SECTION 009113 – ADDENDUM ONE

- A. Project Name: 21034.01 – West Bolivar Consolidated School District ESSER – Phase 2.
- B. Owner: West Bolivar Consolidated School District, 909 Hwy 8, Rosedale, MS 38769.
- C. Architect: Dale | Bailey Architects, An Association, One Jackson Place, Suite 250, 188 East Capitol Street, Jackson, MS 39201.
- D. Architect Project Number: 21034.01
- E. Date of Addendum One: 29 June 2023

2 POWER PLAN - ALTERNATE #1
 E-101 Scale: 1/8" = 1'-0"

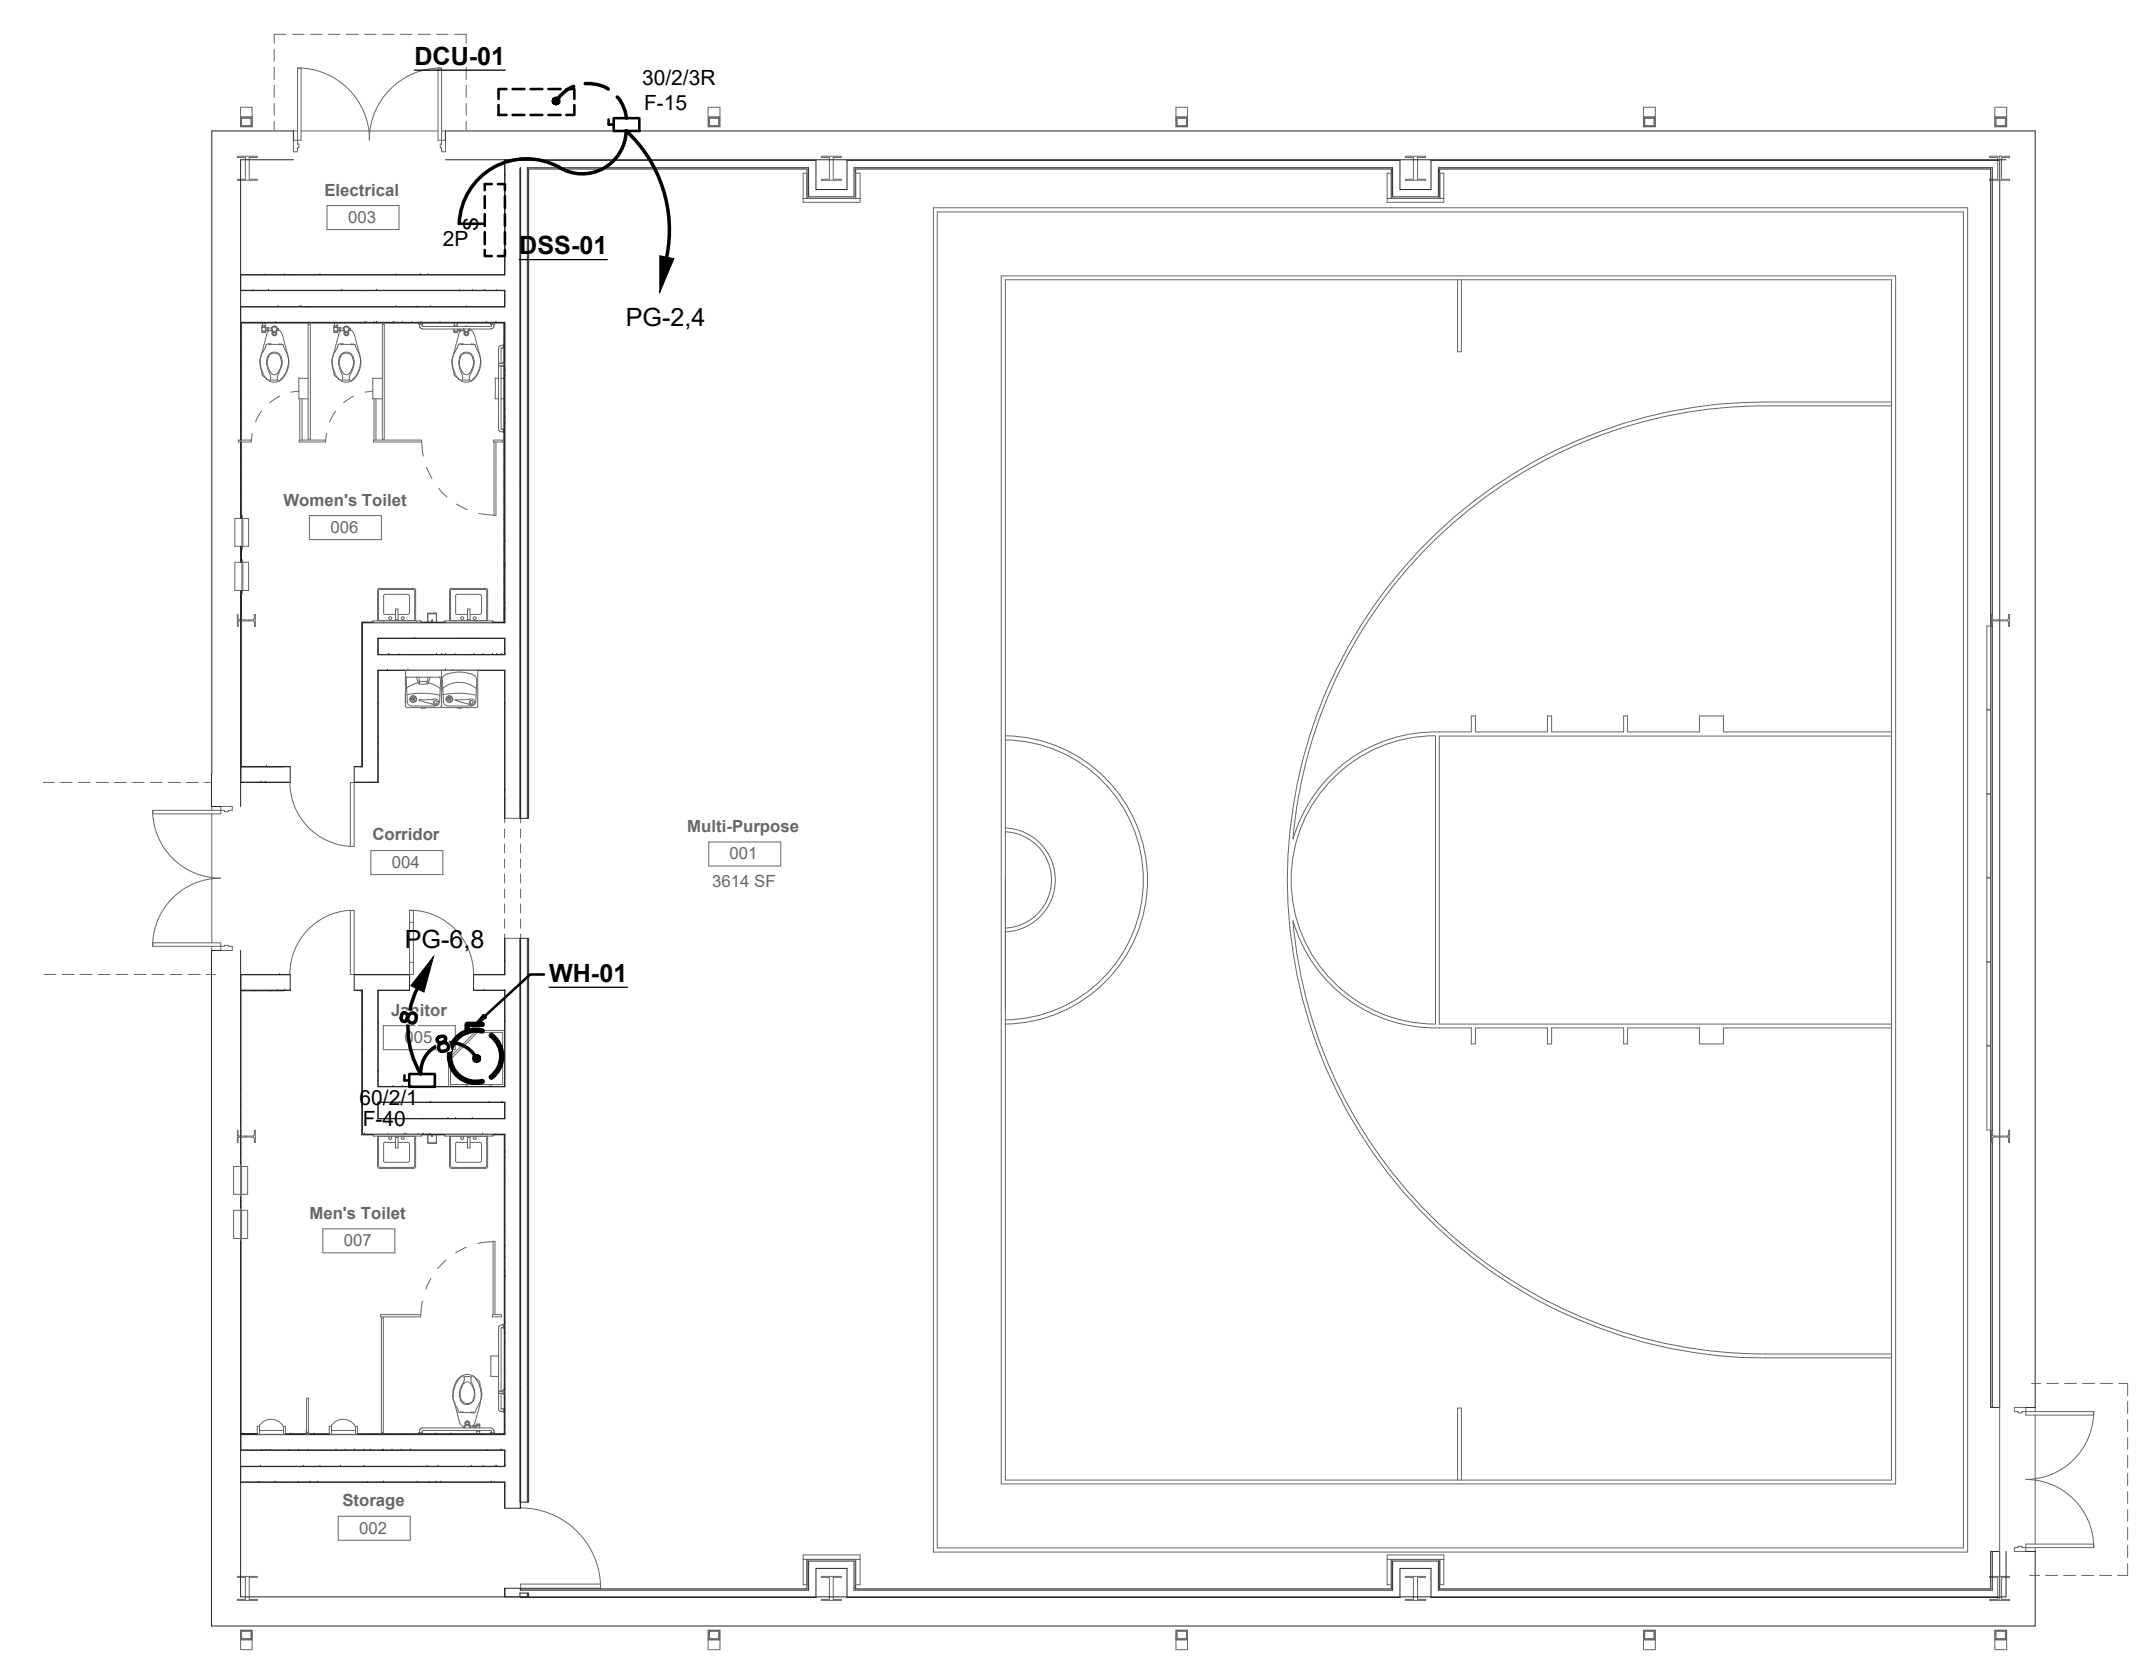
- A. Question: There are no Fire Alarm shown on E-101.
Answer: There is no fire alarm system in this building.
- B. Question: There are no cameras shown on E-101.

- C. Question: There is a W item on power plan on E-101 shown in multi-Purpose and corridor, see highlighted picture below. Is this Wi-Fi or sound? If this is Wi-Fi, who is responsible for installation?

- D. Question: There is an S item on power plan on E-101 shown in multi-purpose, see highlighted picture below.

Answer: See attached revised E-101 for camera locations.

Answer: This is a Wi-Fi. Electrical to install box and cat6.

Answer: Wall mounted speaker.
